Subject:
S2021-104 Preliminary Plat of South Orchard (Remand)

**CITY OF RICHLAND DEVELOPMENT SERVICES DIVISION
STAFF REPORT TO THE HEARING EXAMINER**

PROPOSAL NAME: South Orchard - Preliminary Plat

In response to the remand, the plat has been revised by excluding those lots proposed to be accessed via private drive or alley. In doing so, the lot count was reduced by two. On the topic of the incomplete TIA, revised application materials include a memo from TENW (author of the TIA) suggesting certain transportation improvements would be reasonable to mitigate traffic impacts of the South Orchard proposal. The TENW memo is provided herein as Exhibit 4.

Sheet Title:
ROAD SECTIONS

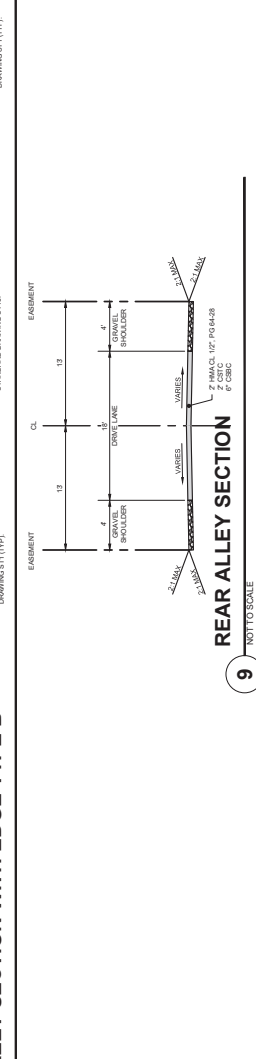
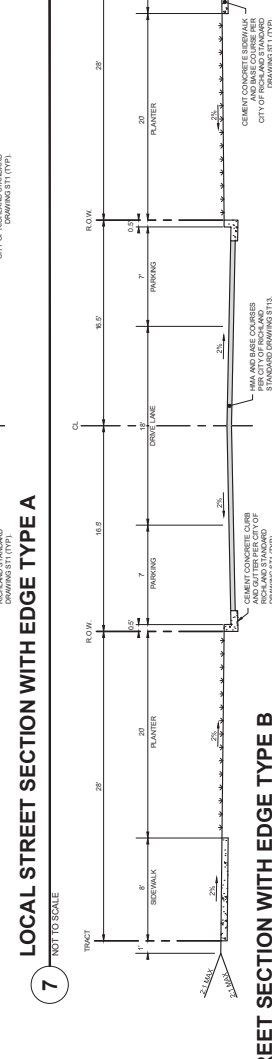
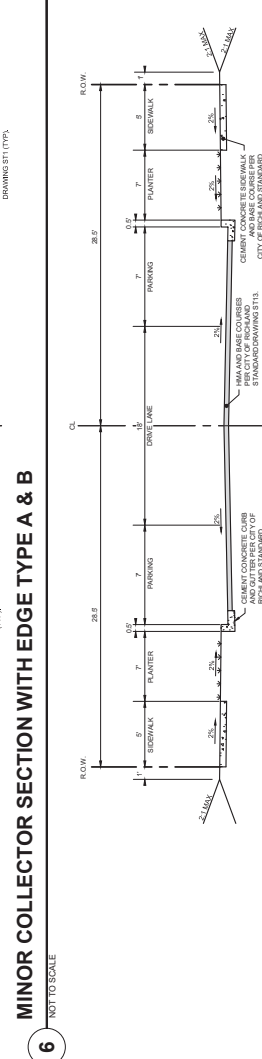
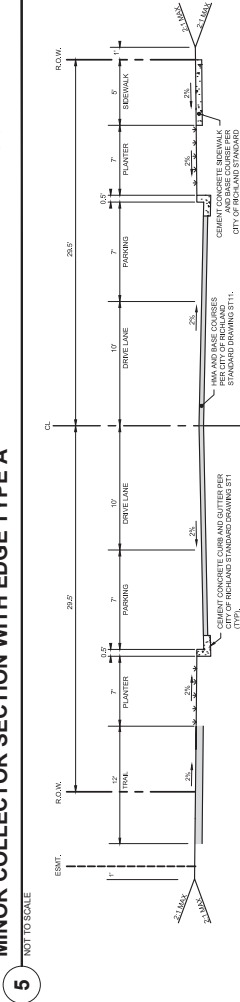
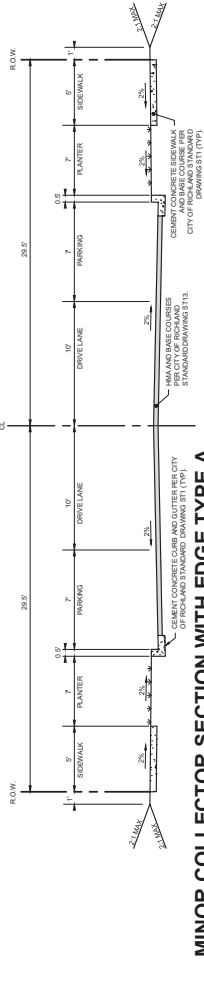
24. Sheet C002 identifies a road section with a median, however it is not clearly identified where that road section is intended to be within the pre-plat. Medians shall not interfere with left-turning movements at intersections. The developer shall obtain approval from the City's Traffic Engineer for all median designs.
